**TOWN OF NEWBURGH
PLANNING BOARD
TECHNICAL REVIEW COMMENTS**

PROJECT: MCDONALDS ROUTE 32-NORTH PLANK ROAD
PROJECT NO.: 17-26
PROJECT LOCATION: SECTION 1, BLOCK 1.1, LOT 76
REVIEW DATE: 30 OCTOBER 2017
MEETING DATE: 02 NOVEMBER 2017
PROJECT REPRESENTATIVE: HARRIS BEACH/BOHLER ENGINEERING- WARREN NJ

1	INLET FILTER	N.T.S.	2	CURB INLET FILTER	N.T.S.
---	--------------	--------	---	-------------------	--------

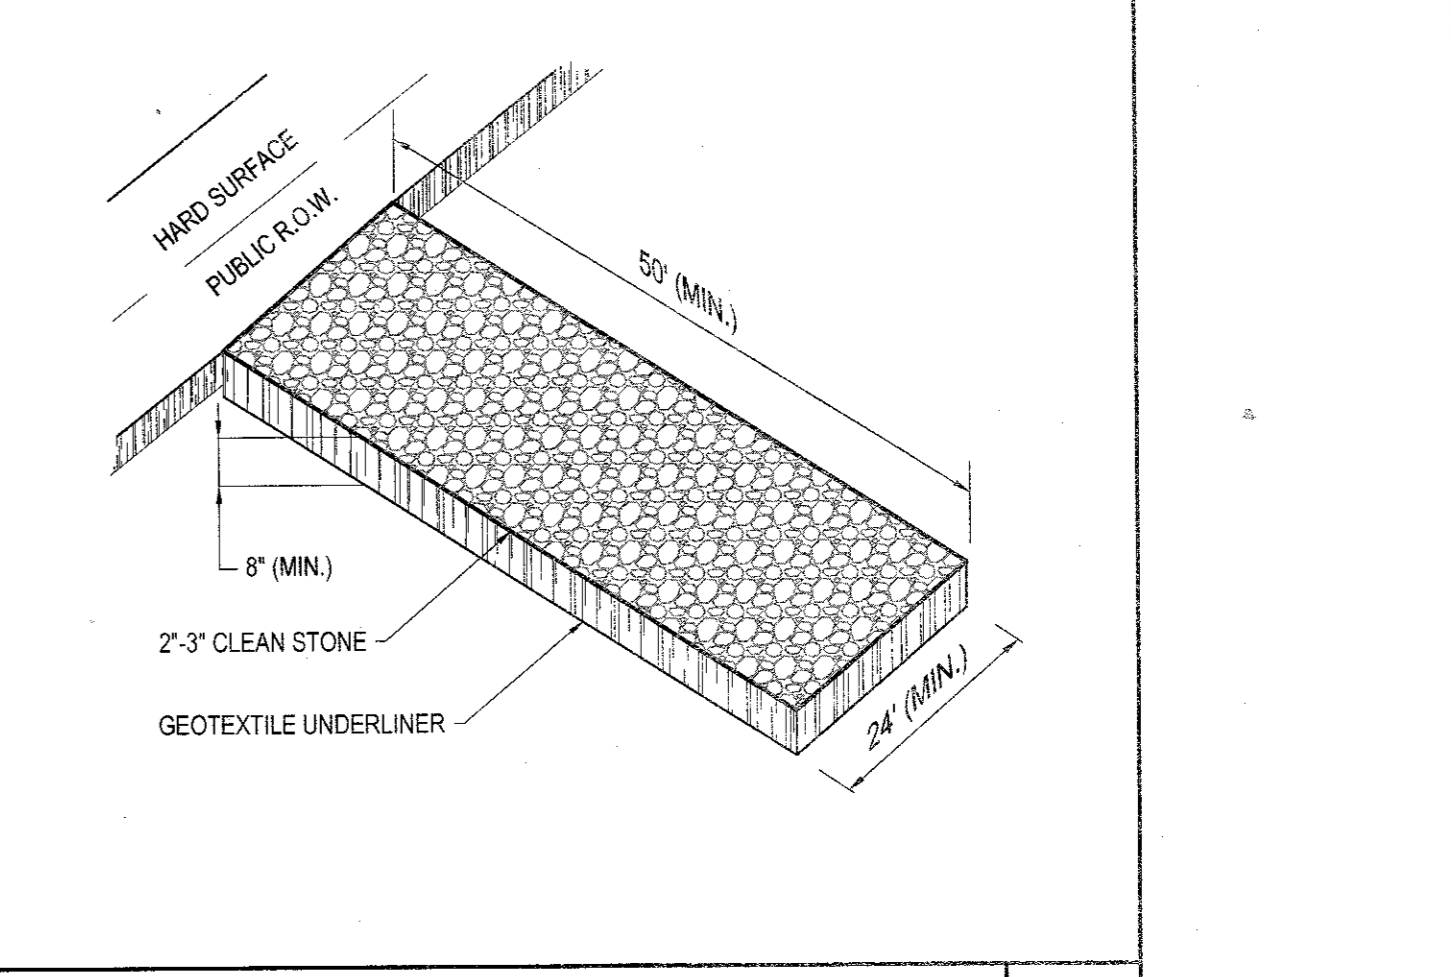
15. Erosion control plan contains a curbed inlet filter. This detail does not meet requirements of the NYSDEC's blue book. Covering of storm grates with filter fabric is not an appropriate erosion control methodology.

12 STANDARD STRIPING DETAIL
NOT TO SCALE (S080506-01/2013)

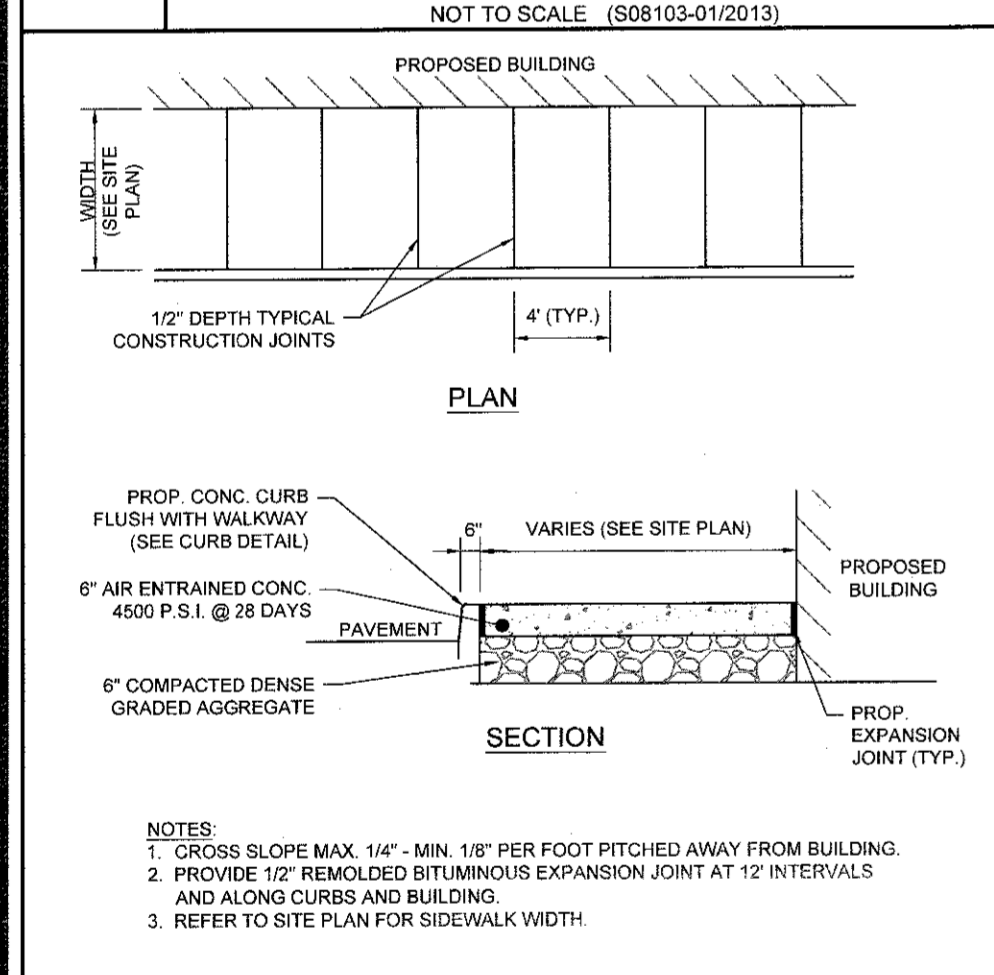
17. Detail 12 on sheet C-13 should be modified to Towns standard striping detail. Similar comment for sheet C-14 detail number 5.
18. Standard Town of Newburgh water and sewer notes must be added to the Plan sheets.

9 F.E.S. FOR REINFORCED CONCRETE PIPE DETAIL
NOT TO SCALE (G020202-01/2013)

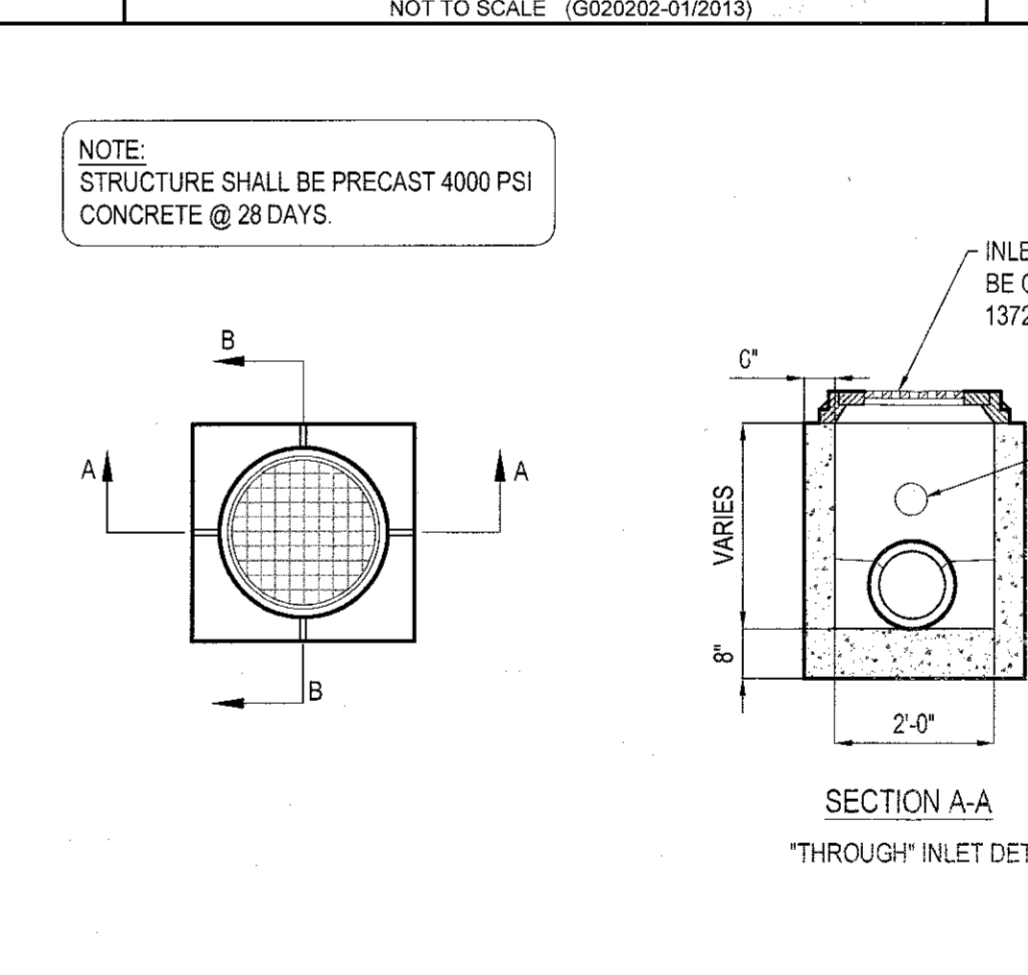
13. A 15 inch flared end section is depicted on the proposed 18 in RCP pipe. This should be clarified.
14. Site lighting plan identifies 20 foot high lighting poles which are higher than the pedestrian scale lighting suggested by the design guidelines. Planning Board's comment on height of lighting should be received with guidance to the Applicant's representative as to compliance with the design guidelines or a request for a waiver of the pedestrian scale lighting.
